COMMONWEALTH OF KENTUCKY
TRANSPORTATION CABINET

CALL NO. 110
CONTRACT ID NO. 204208
ADDENDUM # 1

Subject: MCCRACKEN COUNTY, HSIP 0601 (209)
Letting September 25, 2020

- (1) Revised - General Summary - Page 95 of 231
- (2) Revised - Paving Summary - Page 97 of 231
- (3) Revised - Typical Sections - Pages 113-116 of 231
- (4) Revised - Proposal Bid Items - Pages 229-231 of 231

US 60 at KY 726 - WESTBOUND APPROACH - BARRIER MEDIAN

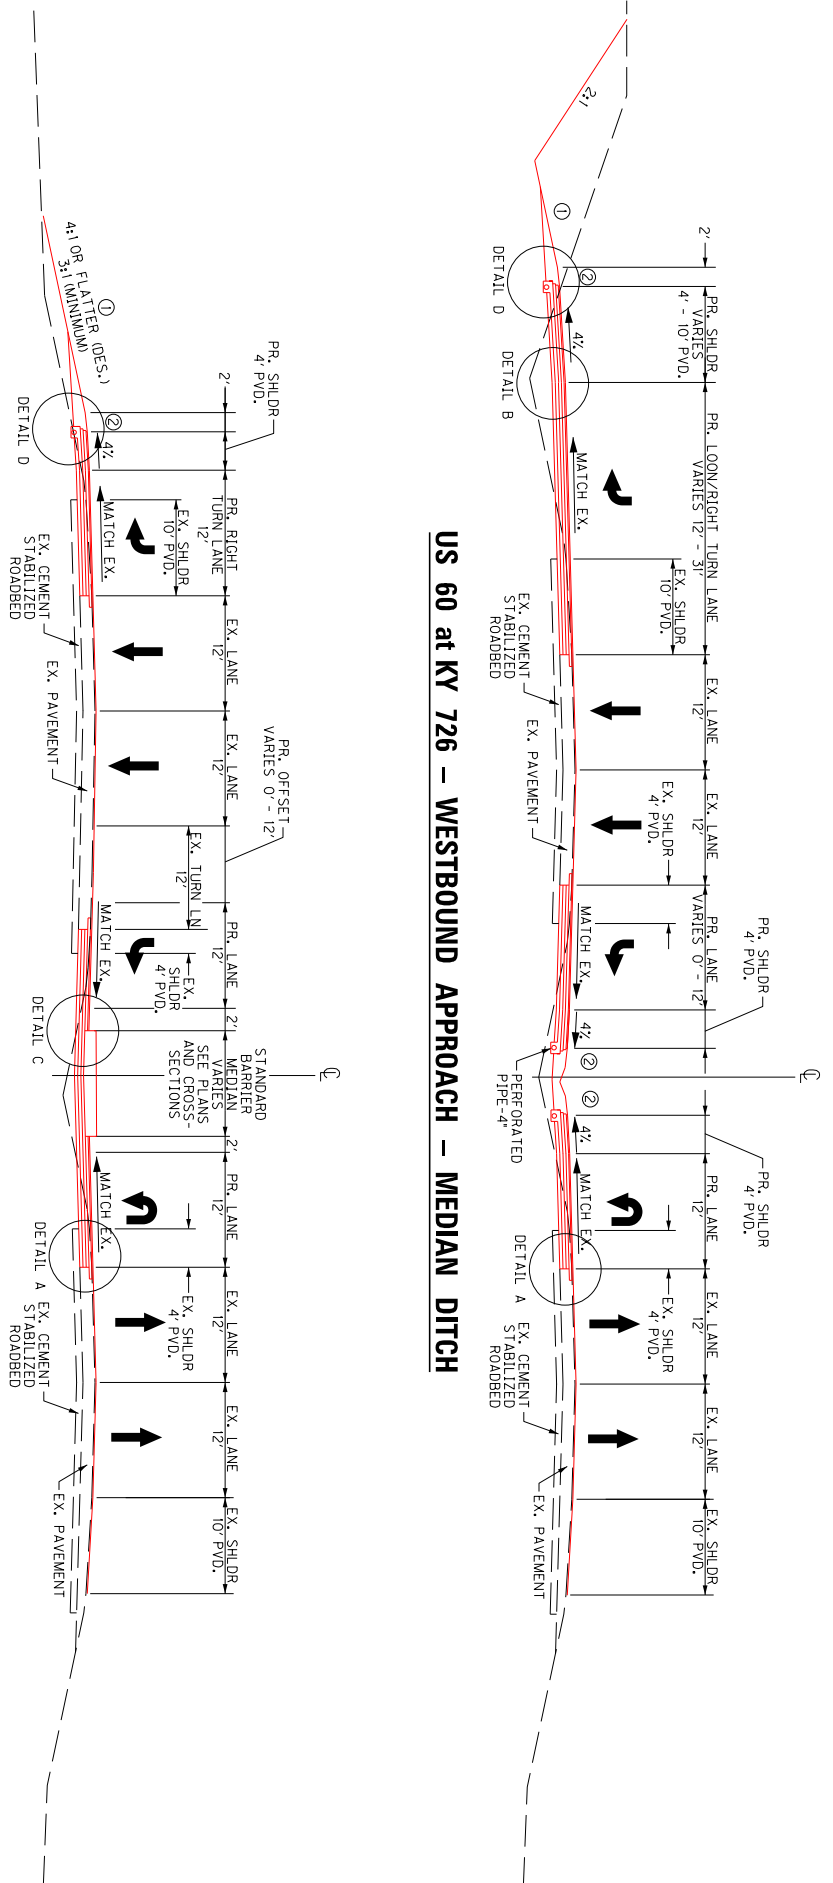
- ③ LAYERS 1 AND 2 OF FULL-DEPTH PAVEMENT SHALL CONSIST OF FIBER REINFORCED ASPHALT AT LOCATIONS SHOWN IN PLANS. SEE SPECIAL NOTE FOR FIBER REINFORCEMENT FOR DETAILS.

US 60 at KY 996 - EASTBOUND APPROACH - BARRIER MEDIAN

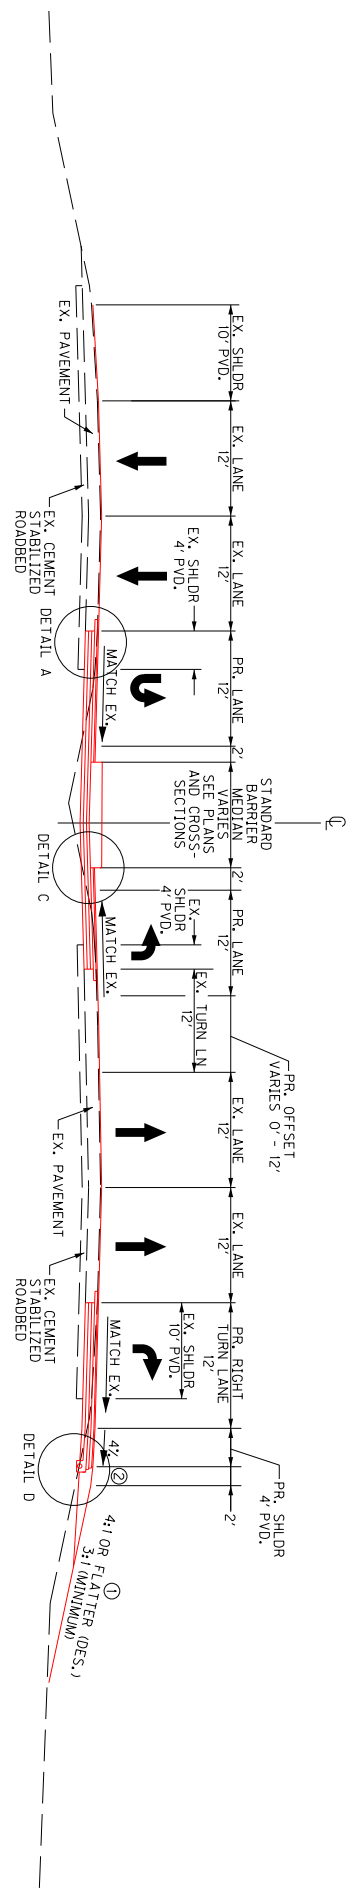
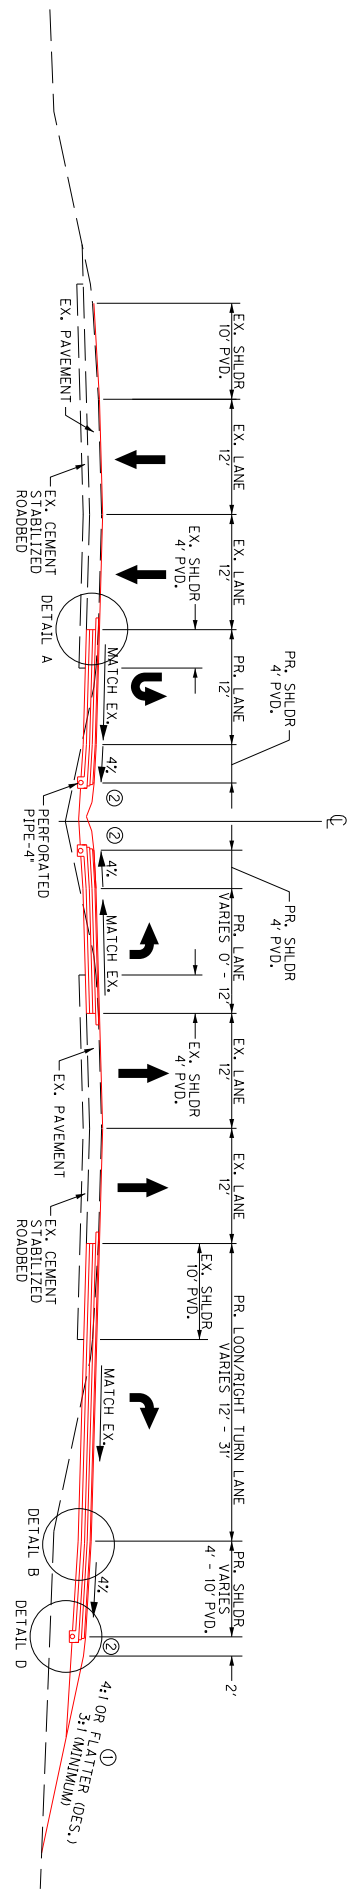
- ③ LAYERS 1 AND 2 OF FULL-DEPTH PAVEMENT SHALL CONSIST OF FIBER REINFORCED ASPHALT AT LOCATIONS SHOWN IN PLANS. SEE SPECIAL NOTE FOR FIBER REINFORCEMENT FOR DETAILS.

US 60 at KY 996 - WESTBOUND APPROACH - SUPERELEVATED - MEDIAN DITCH

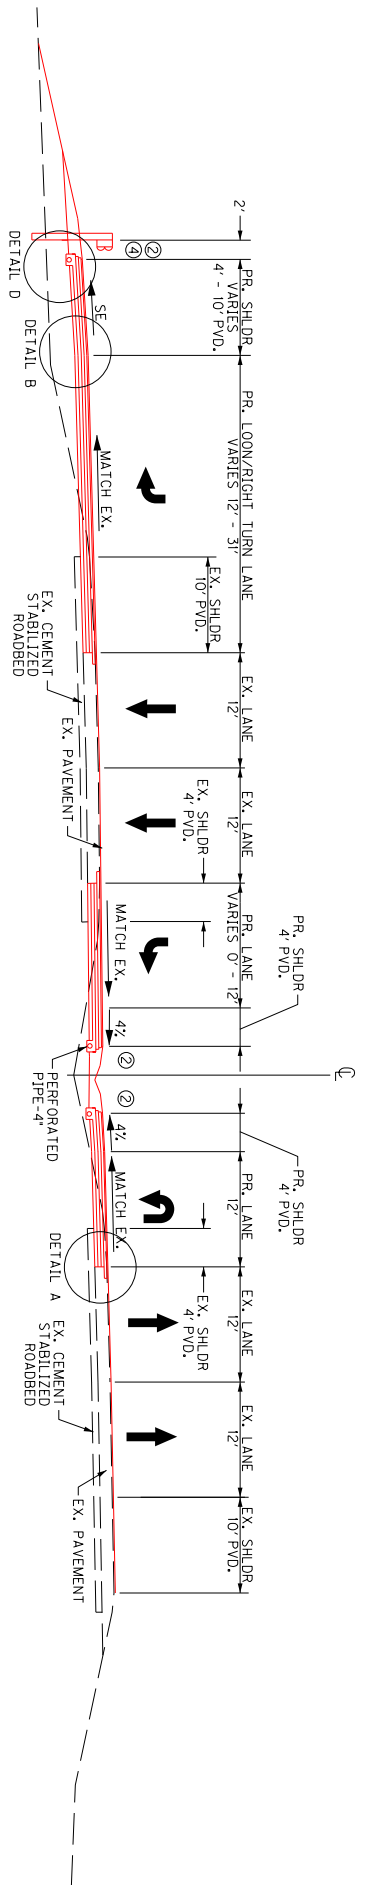
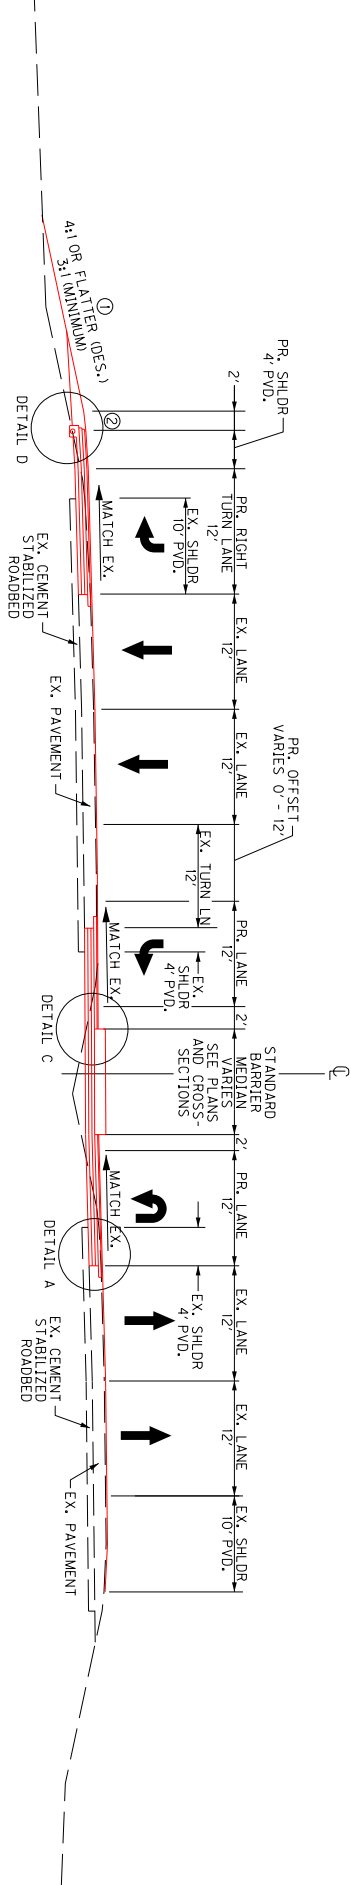
- ① SEE CROSS-SECTIONS FOR SLOPES OUTSIDE THE LIMITS OF THE SHOULDERS.
- ② ASPHALT SEAL REQUIRED FROM THE OUTSIDE EDGE OF PAVED SHOULDERS TO A POINT 2 FEET DOWN THE DITCH OR FILL SLOPE. TWO APPLICATIONS OF THE FOLLOWING:
ASPHALT SEAL COAT 2.40 LB/SQYD
ASPHALT SEAL AGGREGATE 20 LB/SQYD
- ③ LAYERS 1 AND 2 OF FULL-DEPTH PAVEMENT SHALL CONSIST OF FIBER REINFORCED ASPHALT AT LOCATIONS SHOWN IN PLANS. SEE SPECIAL NOTE FOR FIBER REINFORCEMENT FOR DETAILS.
- ④ WIDEN SHOULDER 2' WHERE GUARDRAIL IS INSTALLED.
